ADDENDUM FOR THE ACL 203 DUAL SYNC

This **ACL 203 SN #**

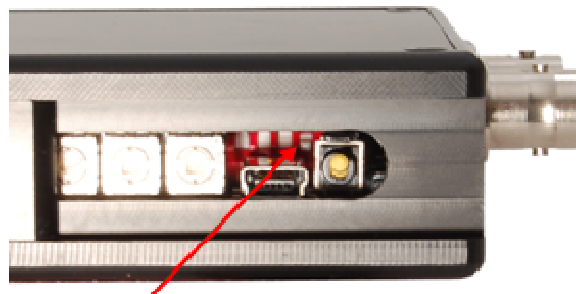
has been modified to offer two independent outputs for Genlock signal.

For this, the center BNC socket was changed to carry the second DA converter's output signal of the Analog Devices Video controller instead of time code.

The signal is identical to output # 1 and locked to it.

Time code is further available via the Lemo 5-pin socket at TTL level (approx. 3.3 Volts pp).

The second DA converter is activated with # 4 of the dip switches behind the USB socket in "down" position.
